# NOTICE OF DECISION

**REPLAT TENTATIVE PLAN / CLASS 3 SITE PLAN REVIEW / CLASS 2  
ADJUSTMENT / CLASS 2 DRIVEWAY APPROACH PERMIT CASE NO.: REP-  
SPR-ADJ-DAP24-06**

**APPLICATION NO.: 24-113646-PLN**

**REQUEST:** A Class 3 Site Plan Review, Class 2 Driveway Approach Permit for development of two new hotel buildings with associated driveways, parking and landscaping, with three Class 2 Adjustment requests:

## DEVELOPMENT PLAN

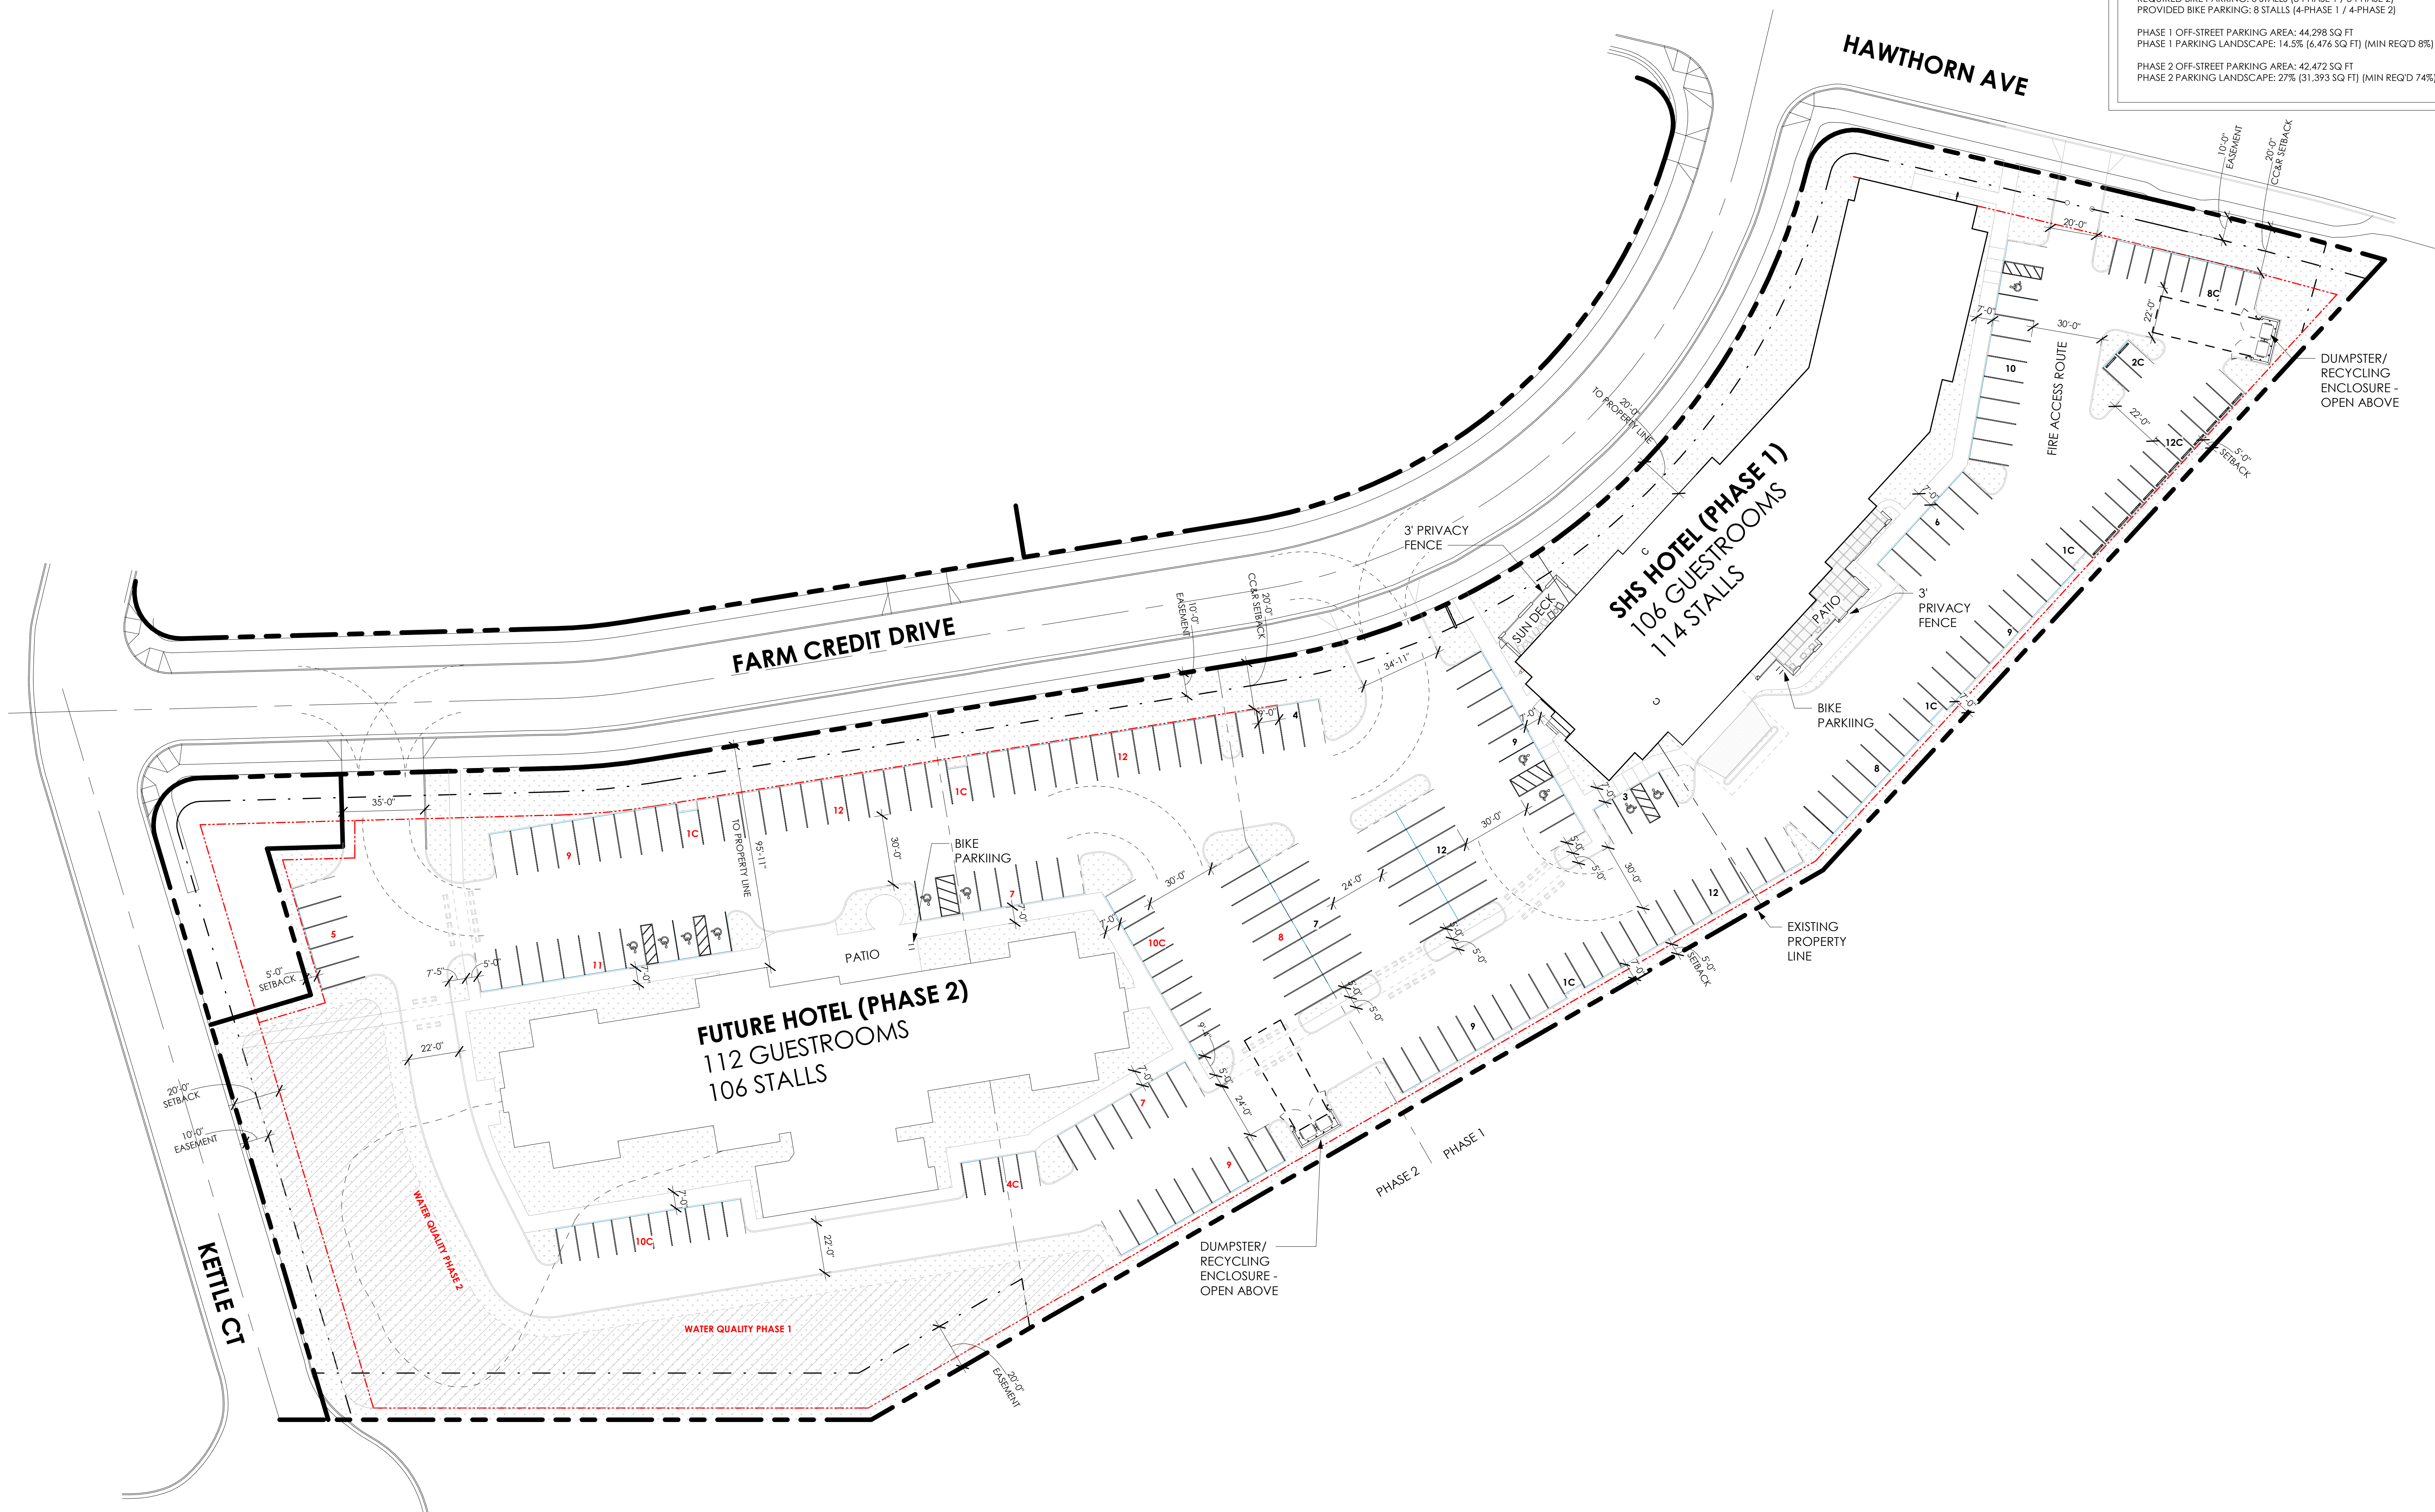
**Finding:** The applicant has provided site plans that are inconsistent with each other, with one listing a minimum of five-percent interior landscaping required and another listing eight percent. The landscaping plans provided are only for the area around Building 1 and state that five percent interior landscaping will be provided, which is not the correct standard. The entire parking area across both properties is approximately 101,215 square feet, with 49,630 square feet around Building 1 and 51,585 square feet around Building 2. Each building permit will require a minimum of eight percent interior landscaping, or 3,970 square feet of landscaping ( $49,630 \times 0.08 = 3,970$ ) for Building 1 and 4,127 square feet of landscaping ( $51,585 \times 0.08 = 4,126.8$ ) for Building 2.

There are 220 parking spaces proposed, requiring a minimum of 18 deciduous shade trees in the interior parking area. The preliminary landscaping plans do not indicate the two required trees nor adequate interior landscaping. To ensure conformance with the interior parking area landscaping requirements of this section, the following condition shall apply.

After discussion, the applicant has provided more detailed canopy plans but still do not meet the 40% coverage under SRC 806.035(n)(1)(c). The applicant has indicated that the intent is to meet the 40% coverage at the time of each building permit. Therefore, the following conditions apply:

**Finding:** The proposed landscape plans only include the land area around Building 1 and do not demonstrate that trees provided are provided along both sides of a driveway in conformance with the planting standards of subsection (n)(3) nor that 30 percent tree canopy area is proposed to cover the surface parking area in conformance with the standards included under subsection (n)(3). As proposed, the development does not conform with the standards in SRC 806.035(n)(2).

The applicant has not provided landscaping plans for the land area around Building 2 and do not demonstrate that trees provided are provided along both sides of a driveway in conformance with the planting standards of subsection (n)(3) nor that 30 percent tree canopy area is proposed to cover the surface parking area in conformance with the standards included under subsection (n)(3). As proposed, the development does not conform with the standards in SRC 806.035(n)(2).

**Condition 17:** The applicant shall provide updated landscaping plans meeting the eight-percent standard for each building permit and the minimum amount of deciduous shade trees within the interior of the off-street parking area, meeting the standards of SRC 806.035(d).

**Condition 20:** At the time of building permit for Building 1, plans showing tree canopy area shall be provided, in conformance with the standards included under subsection (n)(3) of this section, covering at least 40 percent of new off-street parking and vehicle use areas in no more than 15 years.

**Condition 22:** Prior to building permit issuance for Building 1, updated development plans shall be provided demonstrating compliance with the provision of tree canopy

standards in SRC 806.035(n)(2). If the Parking Area is reconfigured to meet this standard, a modification to this decision may be required.

**Condition 23:** Prior to building permit issuance for Building 2, updated development plans shall be provided demonstrating compliance with the provision of tree canopy standards in SRC 806.035(n)(2). If the Parking Area is reconfigured to meet this standard, a modification to this decision may be required.
